**Re: Work Plan Addendum and Phelps Dodge Sierrita, Inc. Response  
to ADEQ Work Plan Comments Mitigation Order on Consent, Docket No: P-500-06**

### Summary of Resolutions on ADEQ Comments Based on the October 11, 2006 Meeting between ADEQ and PDSI

### **PDSI RESPONSES TO ADEQ COMMENTS**

# **GENERALIZED WELL CONSTRUCTION DIAGRAM FOR WELLS WITH SINGLE SCREENED INTERVALS**

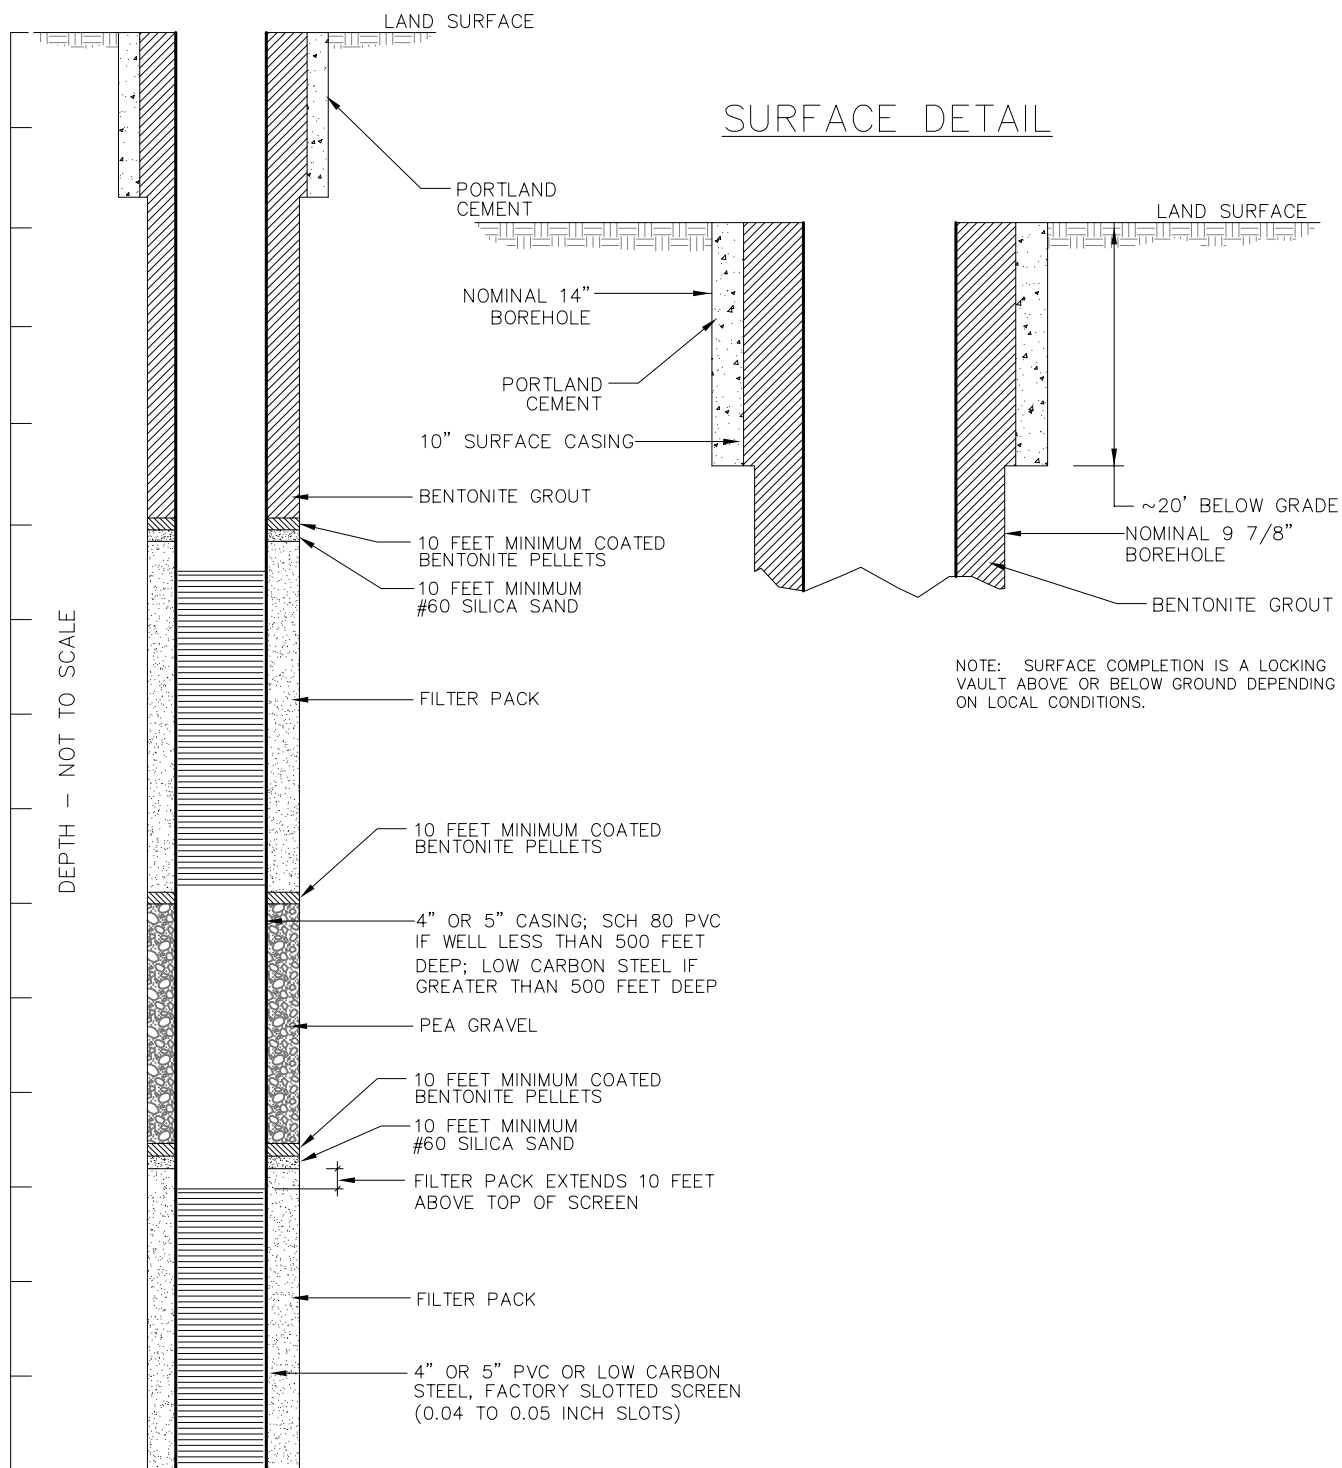
In the October 11, 2006 meeting, ADEQ identified three items as gaps in the QAPP: a list of wells to be sampled for the groundwater monitoring program (Task 2.2), a well construction diagram, and a response to ADEQ's comments regarding data review, verification and validation. These issues are addressed below to complete the QAPP.

The Work Plan and QAPP describe only general well construction methods and strategies because exact materials will be finalized based on discussion with drilling contractors, and the specifics of well depth and screened intervals will be determined in the field by the site geologist based on geologic and water quality conditions encountered during drilling. Figures 2 and 3 provide generic well construction diagrams for the two types of monitoring well constructions, single screen completions and dual screen completions, described in the Work Plan.
